SUBJECT: NRC INSPECTION REPORT NO. 70-143/2006-006

SUBJECT: SPECIAL INSPECTION TEAM CHARTER FOR NUCLEAR FUEL
SERVICES (NFS) - DOCKET NO. 70-143 (INSPECTION REPORT
NUMBER 70-143/2006-006)

Report No.: 70-143/2006-006

Nuclear Fuel Services, Inc.
NRC Inspection Report 70-143/2006-006

Figure 1: Event time line showing three previous occasions where either a small amount yellow solution or evidence of yellow solution was found in the bag filter enclosure (ENCLOS-2M05).

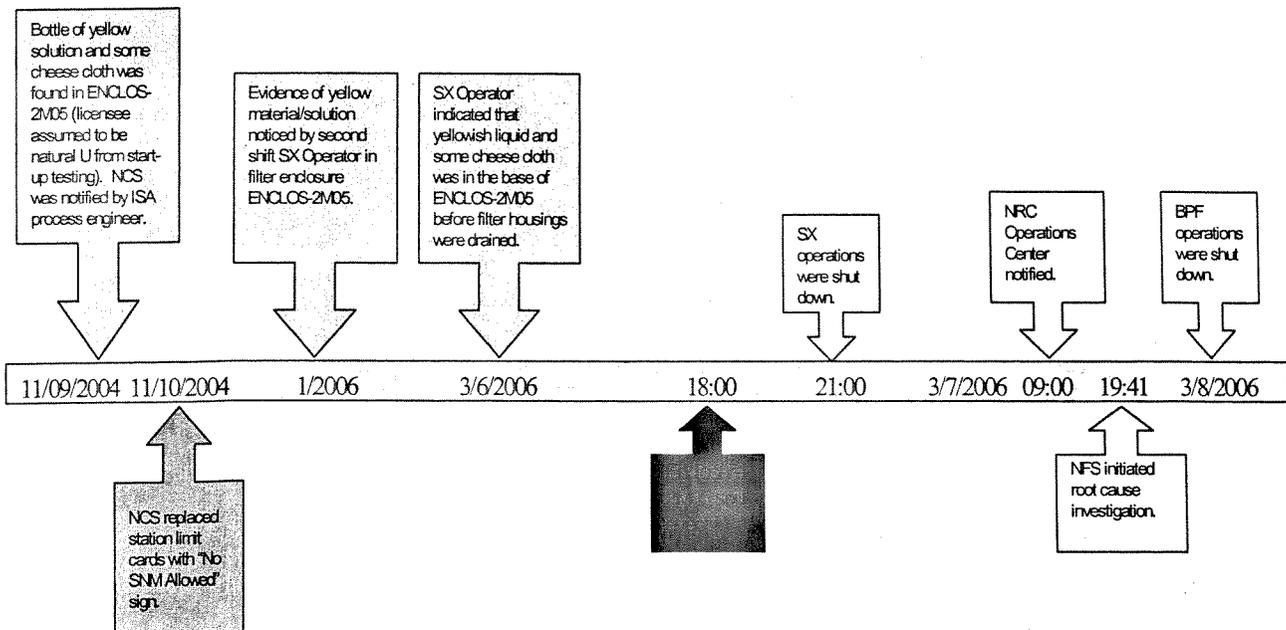
The inspectors noted that there were three previous occasions where either a small amount of yellow solution or evidence of yellow solution was found in the enclosure (see Figure 1). The operators involved reported their observations to their supervisor. The personnel involved thought the material was depleted uranium solution from start-up testing. None of the observed events were reported in the licensee's problem identification, resolution, and correction system (PIRCS).

Figure 2: BPF Tray Dissolver 2M05 Enclosure, Piping and Drains

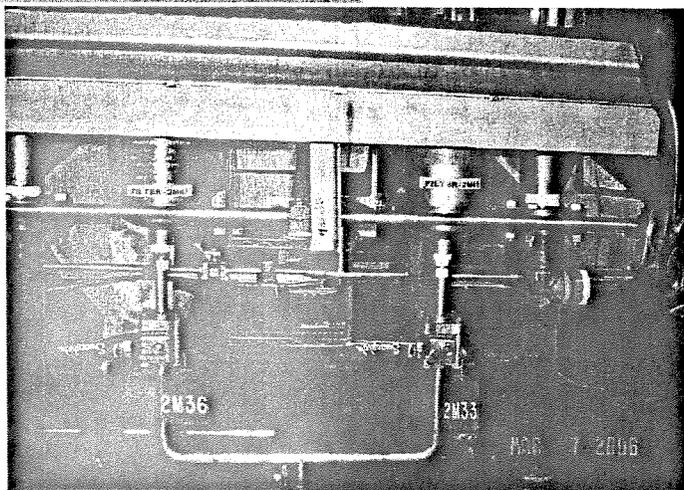
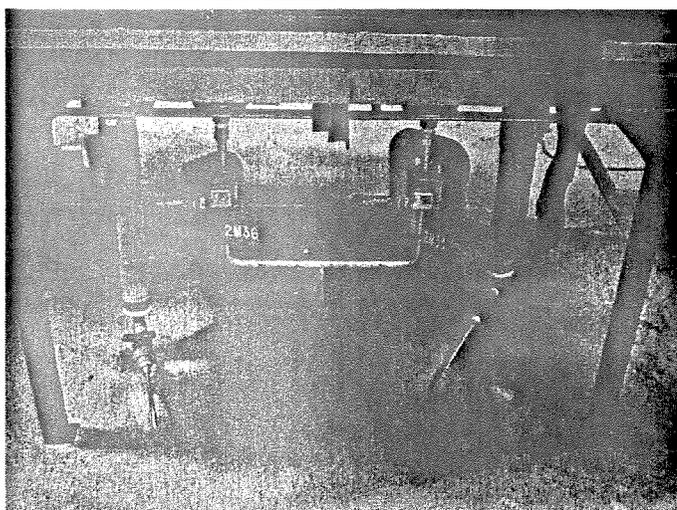
The tray dissolver filter enclosure had two engineered NCS controls consisting of two drains which each had a diameter of two inches. There were no management measures in place to ensure that the drains could adequately perform their safety function. Items such as cheesecloth and poly-bottles which could block the drains were observed in the enclosure prior to the event (see Figure 1). The filter enclosure was considered out of service, and there were no approved procedures for enclosure operations including maintenance operations. No station limit card was in place, and operators were not trained on the unit. The licensee intended to use the enclosure drains as IROFS, and the drains would have been procedurally checked for obstructions prior to each use of the equipment. Other management measures on the drains would have included installation checks and preventive maintenance which were also not performed. The inspectors determined that the filter enclosure was uncontrolled for the accident sequence of a spill into the enclosure because these controls and measures were not implemented. In addition, a spill contained in the enclosure would not be easily noticed such that multiple spills to the enclosure could result in accumulation of fissile solution if the drains were blocked.

The licensee had performed an NCS analysis for the tray dissolver equipment and had prepared an operating procedure. The inspectors observed that the completed and approved NCS analysis for the tray dissolver process had reviewed the potential for accumulation of fissile solution in the enclosure and established appropriate NCS controls for that accident sequence which consisted of two 2-inch drains which were intended to be designated as IROFS. Because the system was considered out of service, the drains required by the analysis were not completely implemented, and double contingency was not established for the accident sequence of fissile solution spill into the tray dissolver filter enclosure. Specifically, verification of proper installation of the drains was not completed. License application Section 4.1.1.1.3 states, in part, that engineered controls must be verified as being properly installed prior to first use with fissile material. Failure to verify proper installation of the tray dissolver filter enclosure drains prior to use of the system with fissile material is identified as an apparent violation (APV 70-143/2006-006-02).

Figure 3: Tray Dissolver and Filter Enclosure Equipment Layout

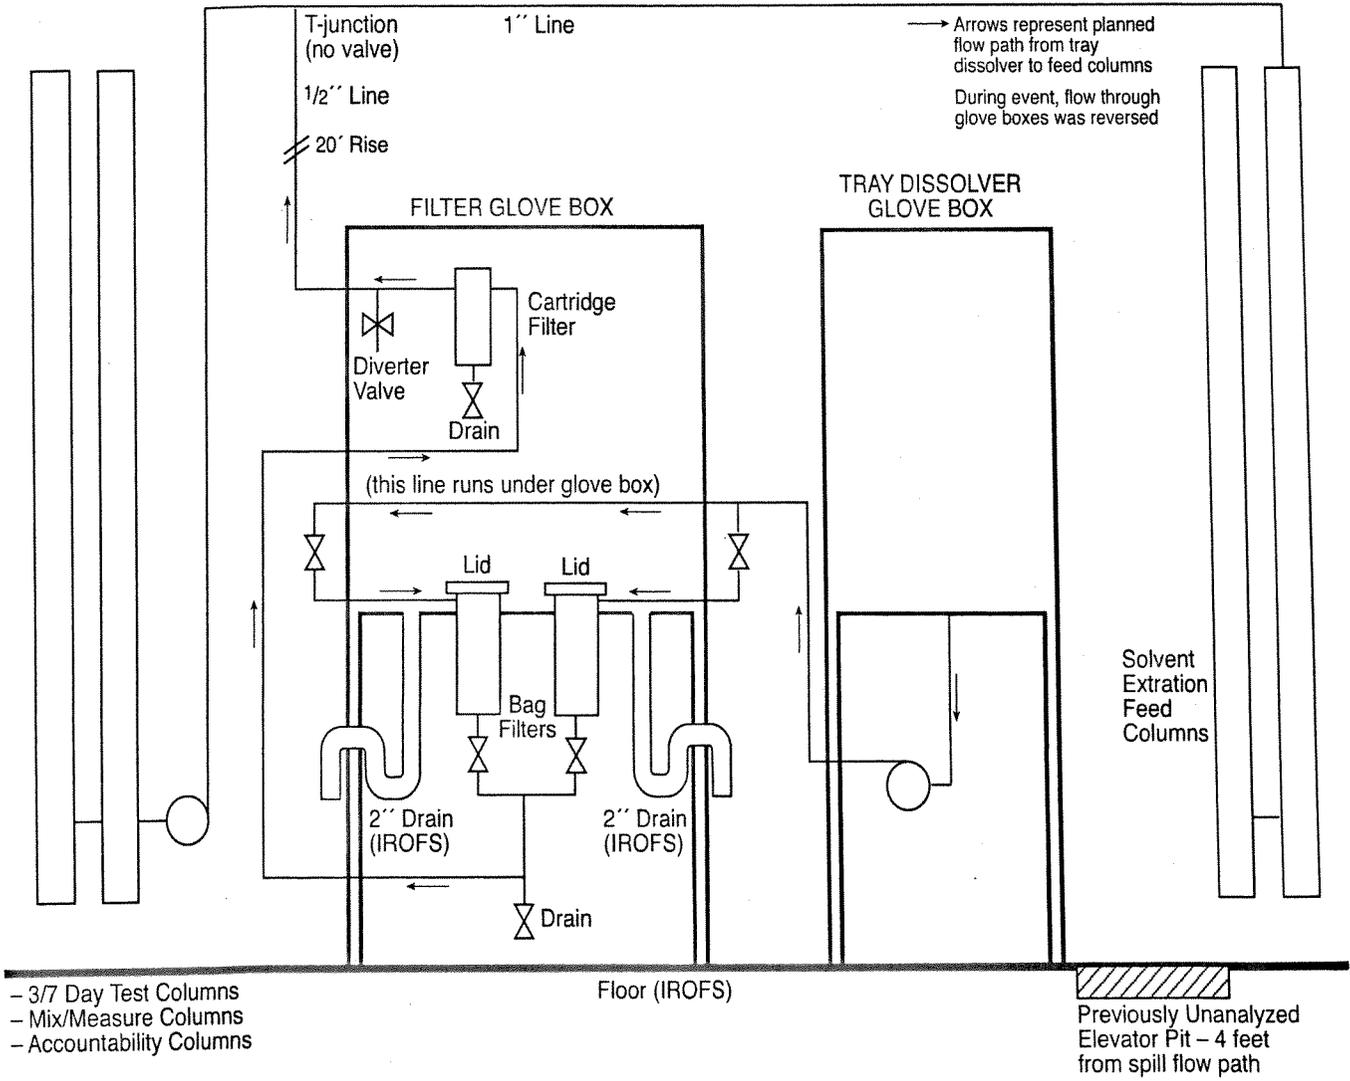
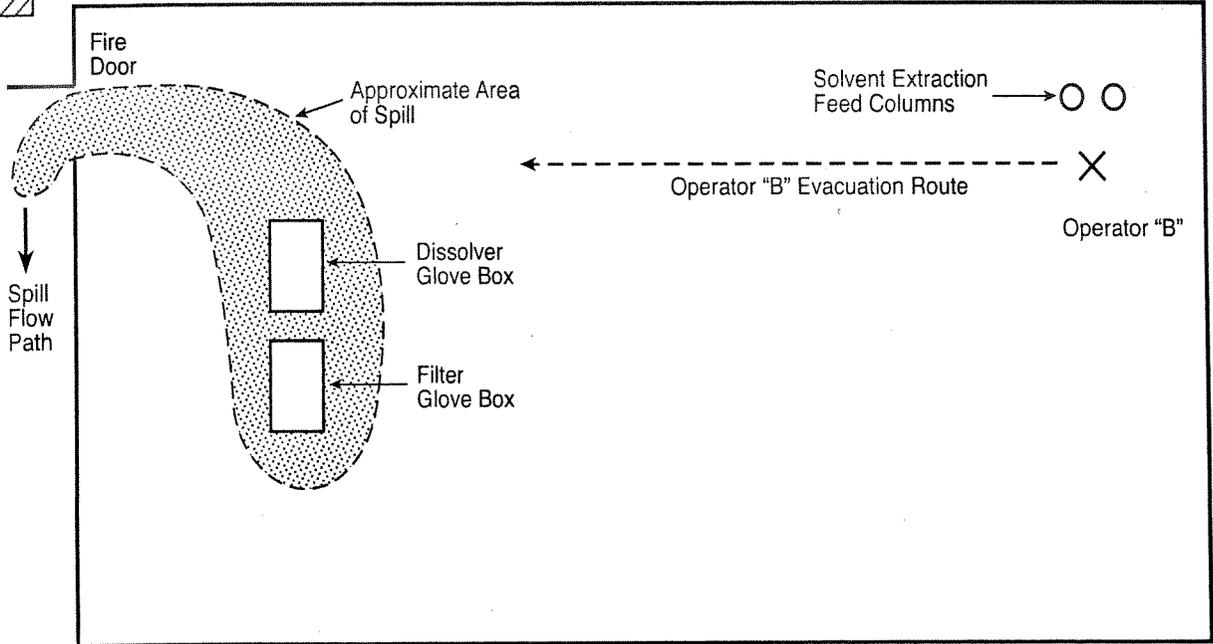
The inspectors noted that the tray dissolver filter enclosure was installed without isolation valves and was connected to fissile process lines, utilities, and ventilation as if the tray dissolver system was in service and would therefore be required to meet the performance requirement of 10 CFR 70.61(d) for accident sequences leading to criticality due to handling fissile material with the tray dissolver equipment. The inspectors determined that because management measures were not implemented for the enclosure drain system, the enclosure did not meet performance requirements for criticality safety relative to accumulation of fissile material in the enclosure or on the floor of the solvent extraction room. Failure to meet the performance requirements of 10 CFR 70.61(d) for accident sequences related to handling fissile material in the tray dissolver system is identified as an apparent violation **(APV 70-143/2006-006-03)**. The inspectors reviewed similar filter enclosures in the plant and observed that they had isolation valves on both sides and an uninterrupted transfer line to the discharge point. No generic issue was identified relative to similar enclosures and equipment in the facility.
